Project Name: Acre Field

Planning Reference: Y_55_22_DOC

Formal Requests

17/02/2023 – Robert West Comments

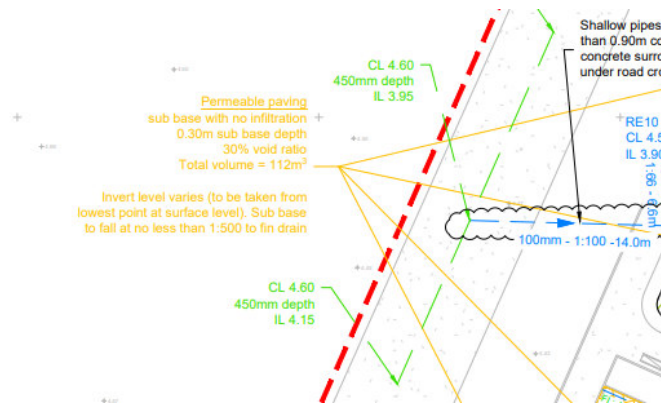
- Point 1 - Further information required:
 - i. Whilst reference has been made to the Factual Ground Investigation Report GL24235 by Harrisons dated May 2021, (ref. note 15, drawing CRH-XX-XX-DR-C-5050-P8_Proposed Drainage Layout (Sheet 1)), this information does not appear to have been submitted for review. The value specified in the applicant's response (infiltration rate of 2.37×10^{-6} m/s), has been applied to the model (calculation pack 0008 - utilising infiltration in the bases of the attenuation basin and the areas of permeable paving as requested). The results of groundwater testing have not been provided.

- Without the test results to verify the infiltration rates applied to model 0008, the results cannot be verified. This infiltration testing is required to confirm that infiltration rates at this location are sufficient to allow for runoff to discharge to the ground as designed. Providing the rates match the testing, the calculations provided are considered acceptable.

Infiltration testing supplied. Accepted.
